REMARKS

The Office Action dated October 27, 2003 has been received and considered by the Applicants. Claims 1-8 are pending in the present application for invention. Claims 1-8 stand rejected by the October 27, 2003 Office Action. The foregoing amendment to the claim adds new Claims 9-16 that are generally of a similar scope to claims 1-9 originally submitted with the present application for invention.

FIG. 1

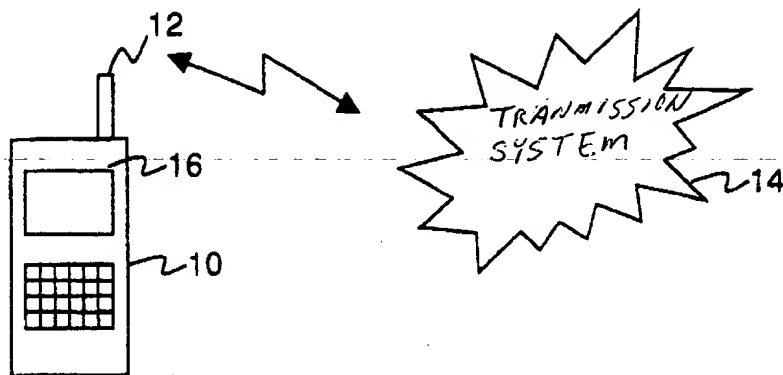
The drawings are objected to because they fail to include descriptive labels of the specific blocks as described in the specification. The Examiner states that in Figure 1, 14 should be labeled "Transmission System", in Figure 2, 25 should be labeled "Video Screen". Redlined drawings are submitted with this response that include descriptive labels of the specific blocks mentioned by the Examiner for Figures 1 and 2. The Examiner states that in Figure 3, blocks KO-K5 should be labeled individually. The Application would like to, respectfully, point out that blocks KO-K5 are described in the specification as blocks KO-K5 and accordingly are labeled as in specification for the present application. The additional verbiage in the specification describes the functions performed by blocks KO-K5. Accordingly, the Applicant, respectfully declines to modify Figure 3 because no such modification is necessary.
